Platform A1 - Booth area  
Previous comments are  
still valid, see following  
slides

Platform A1 – Oven area

Axes 5/023

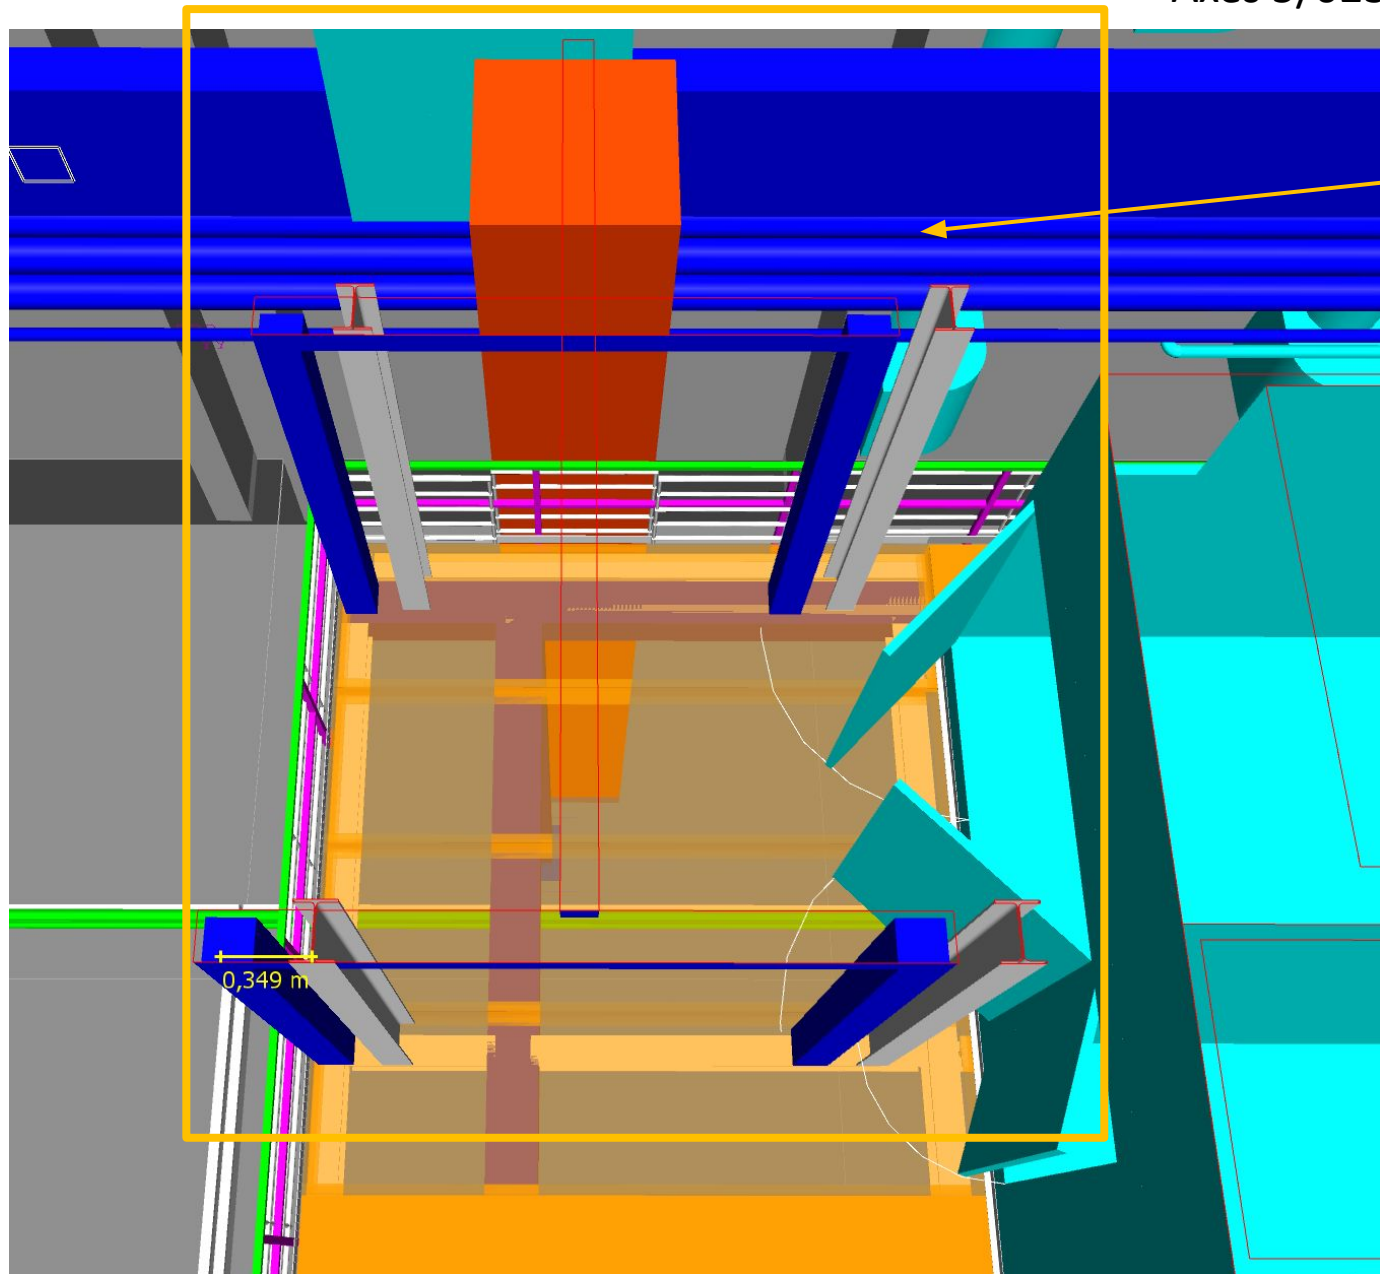
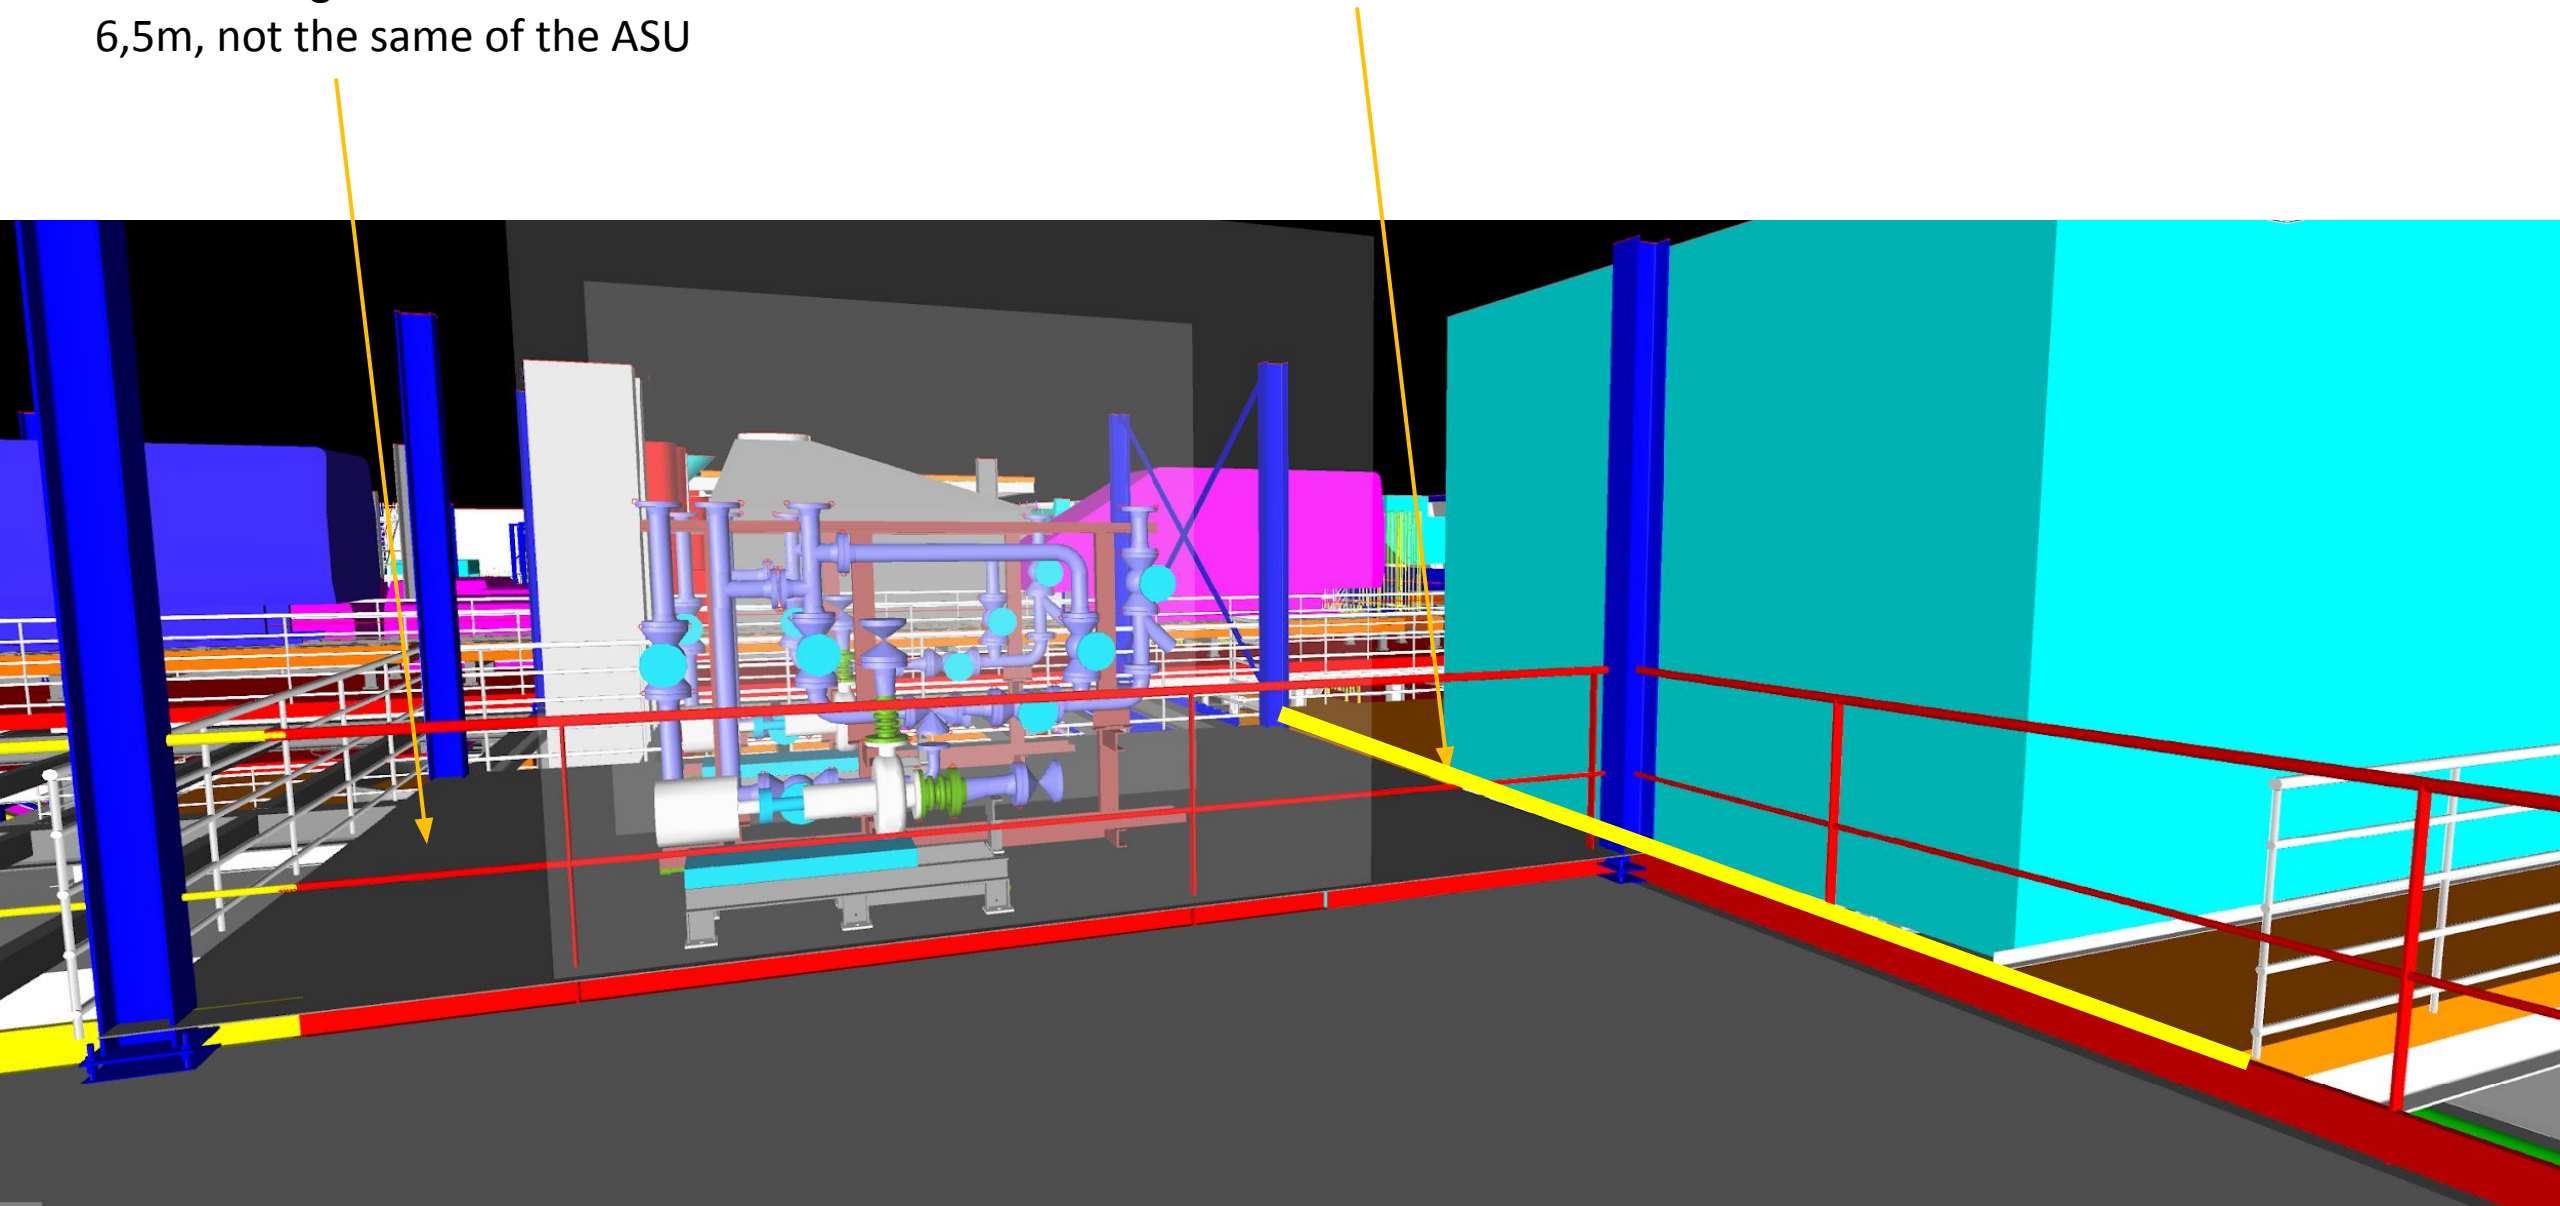
Move monorail columns 350mm left  
according to last gen. Layout (04/05)  
Otherwise ASU doors won't open  
correctly

This walking level should be at elev.  
6,5m, not the same of the ASU

We will have a step along this line

Axes 10/022

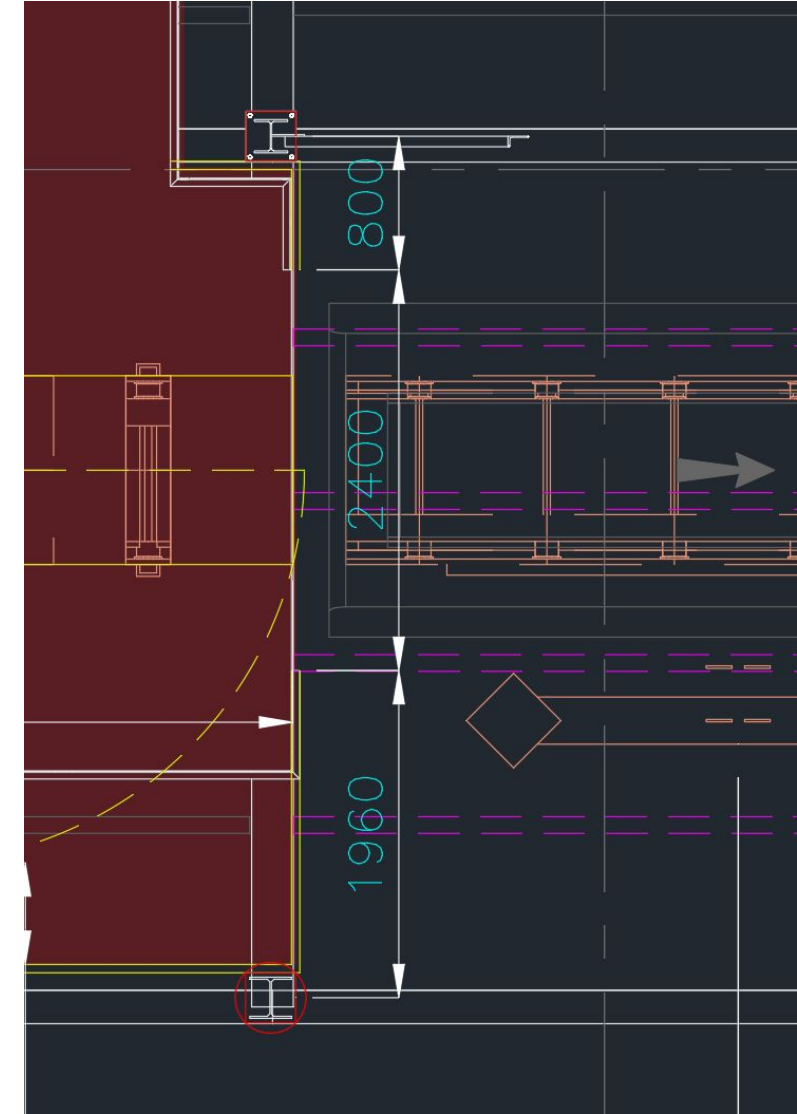
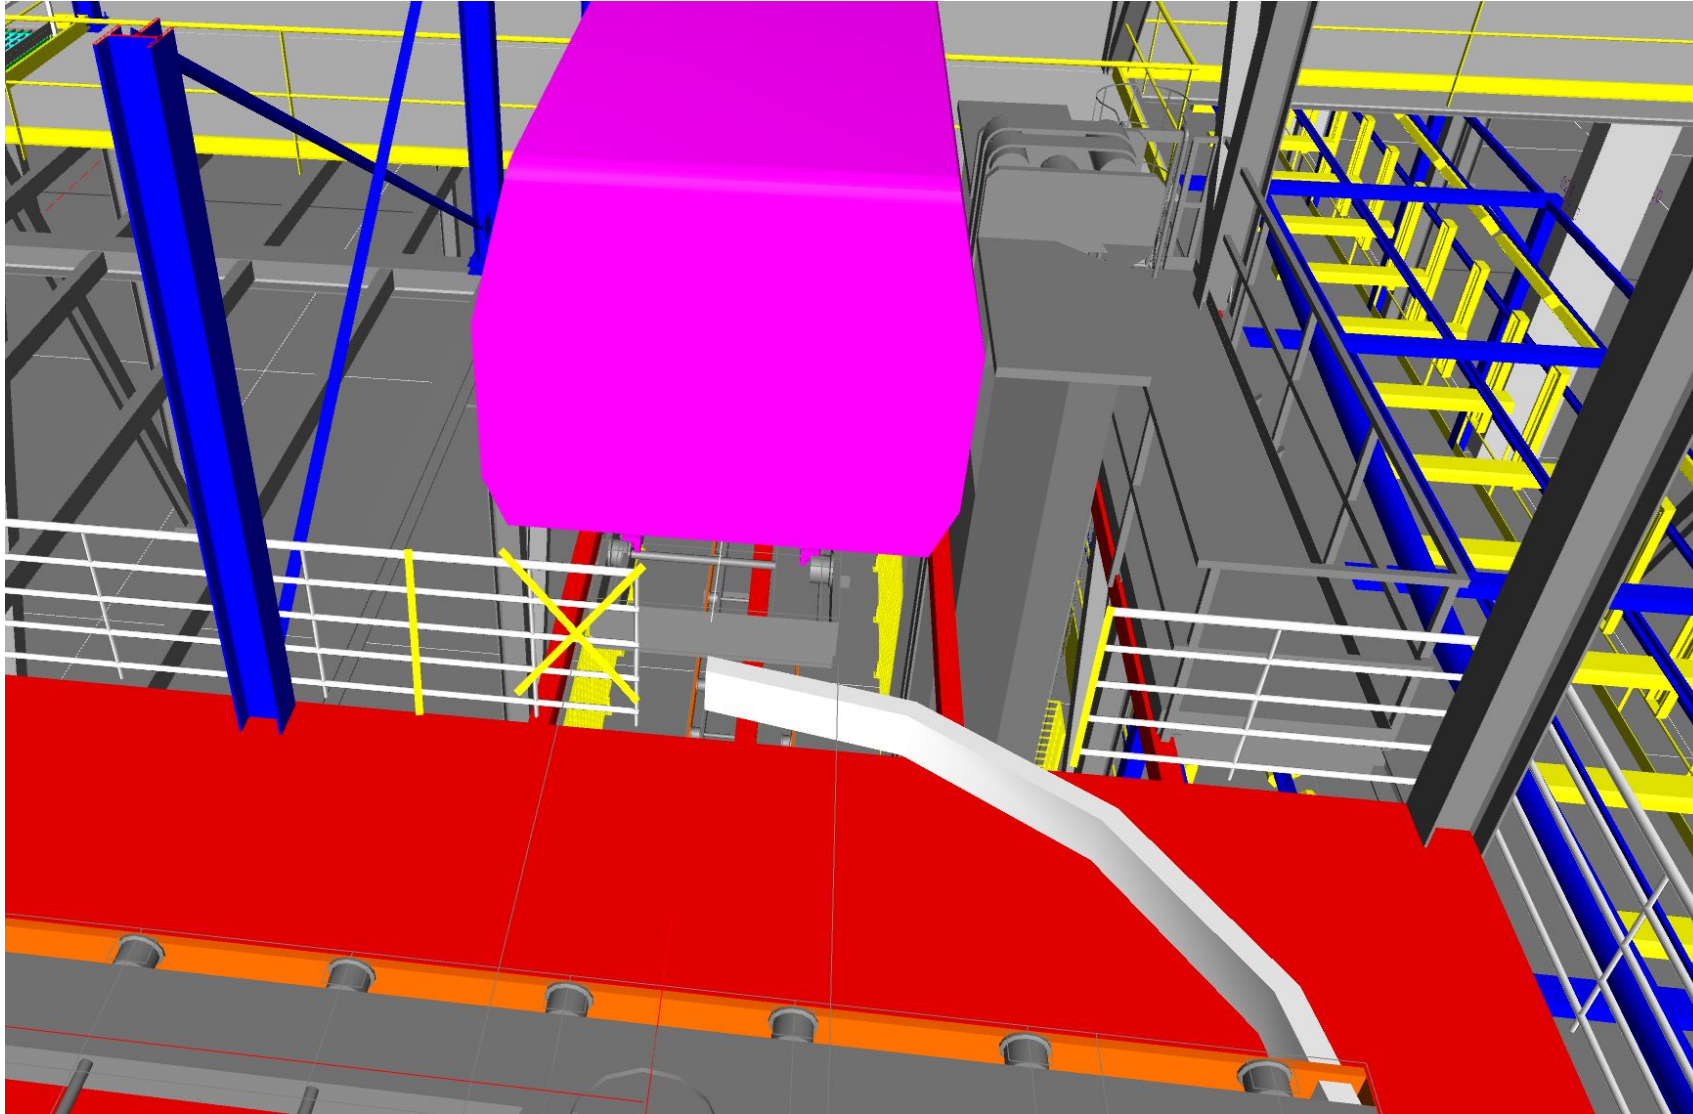
Platform B – (022/10-11): adjust handrail  
according to Layout dimensions (right picture)

Axes 5/017

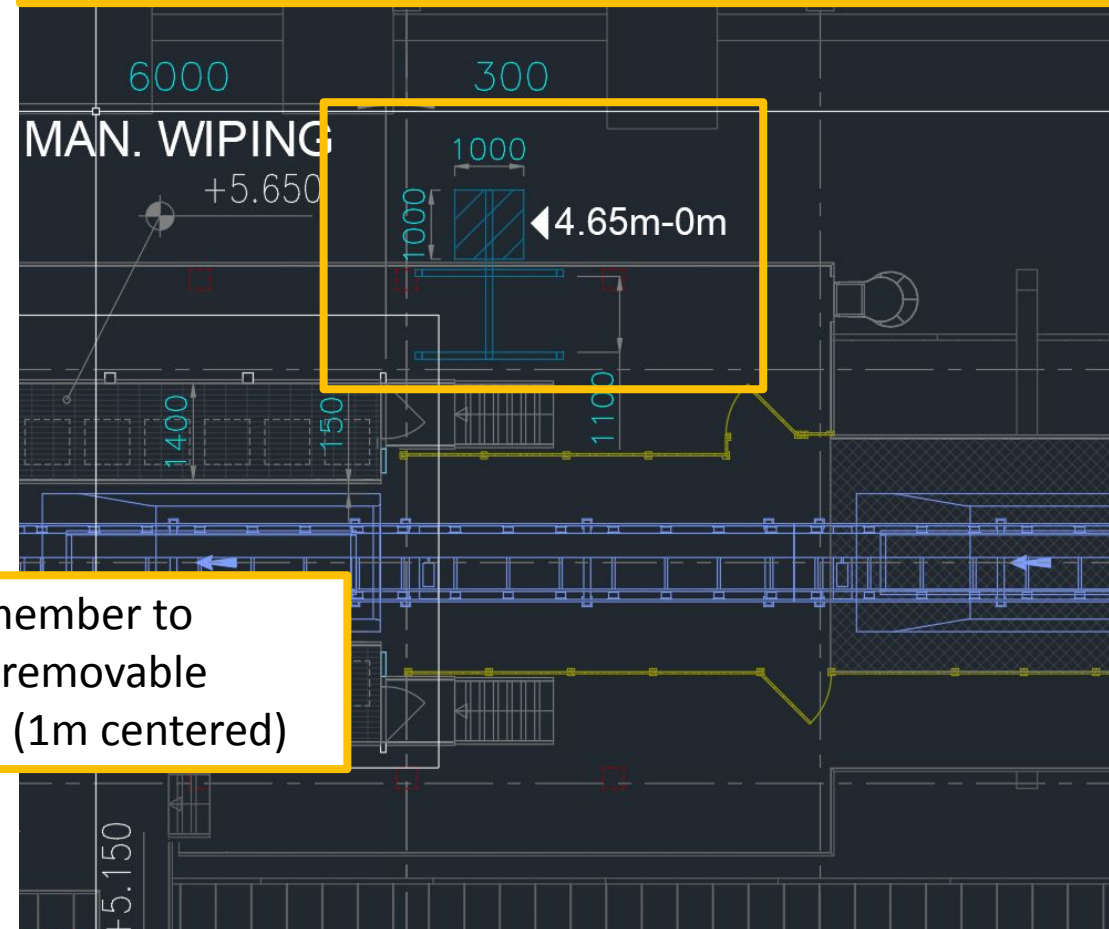
Move monorail from  
0,00 to 4,65 (platf.  
A1)

Looks like you used same monorail of ASU, this should  
be smaller, it downloads only the empty filters of the  
Drypan

Axes 6/016  
Axes 7/016

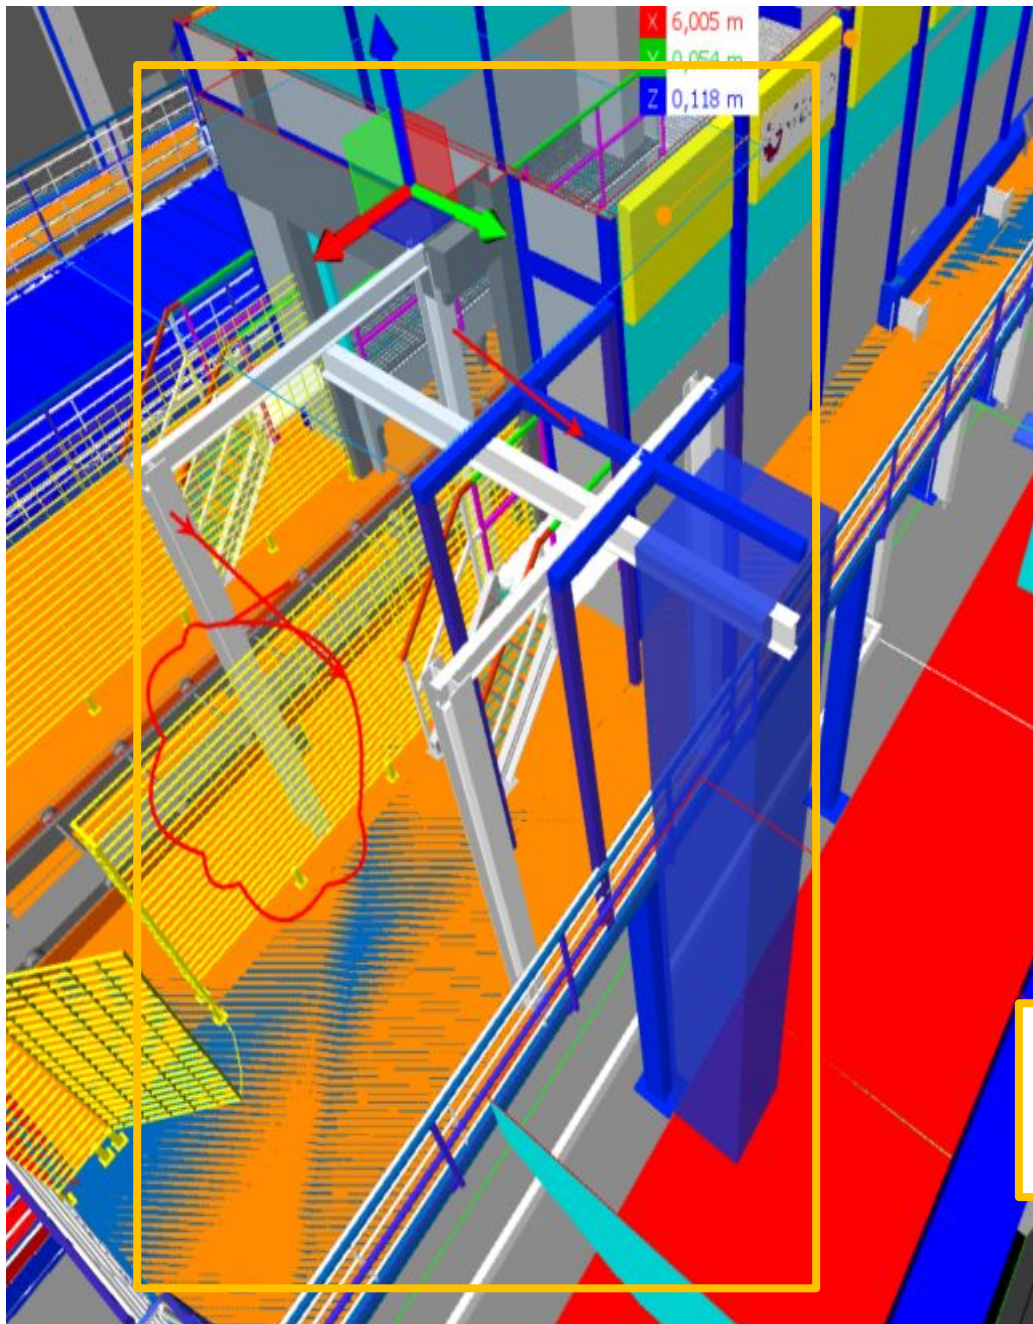
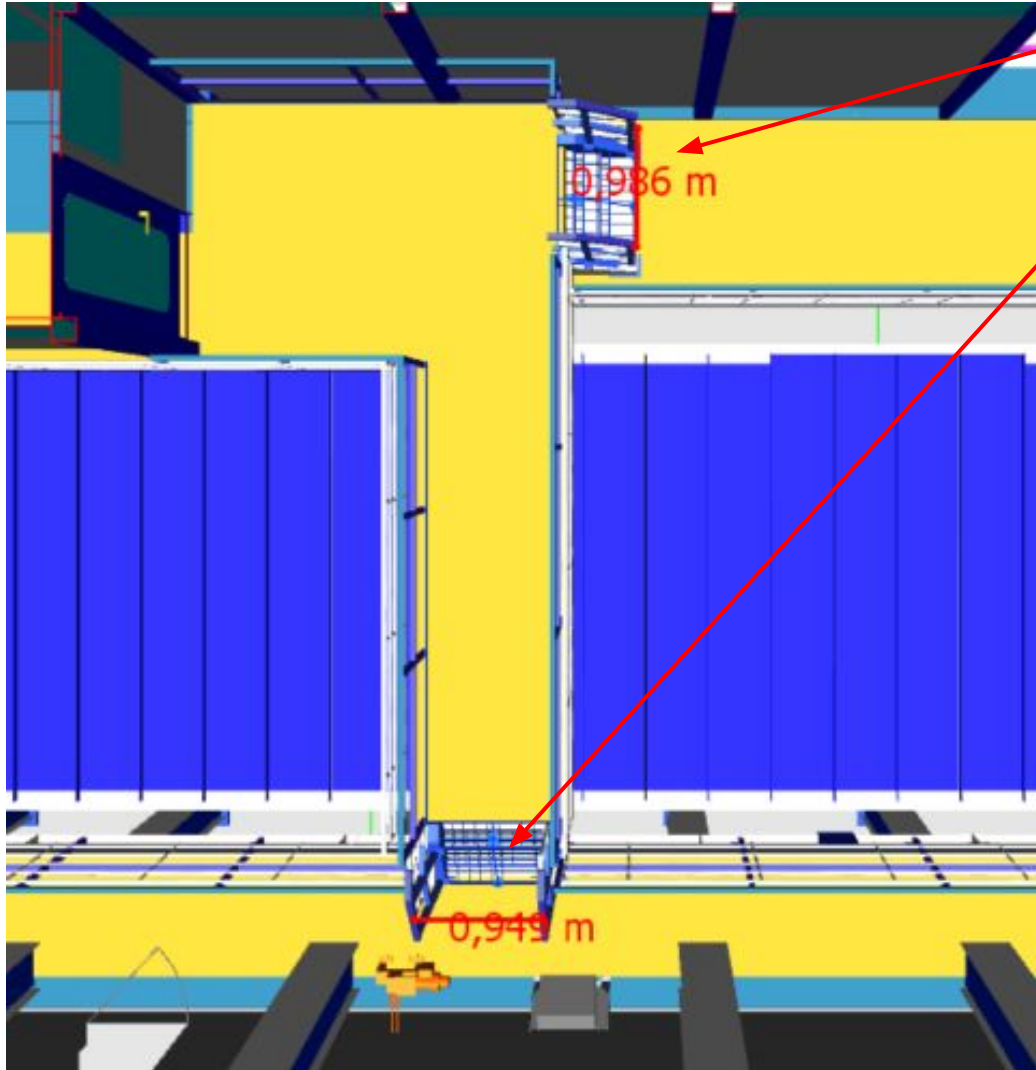
Also remember to  
provide removable  
handrail (1m centered)

Stairs to be minimum 1 meter  
for safety evacuation  
(net dimension between  
handrails)
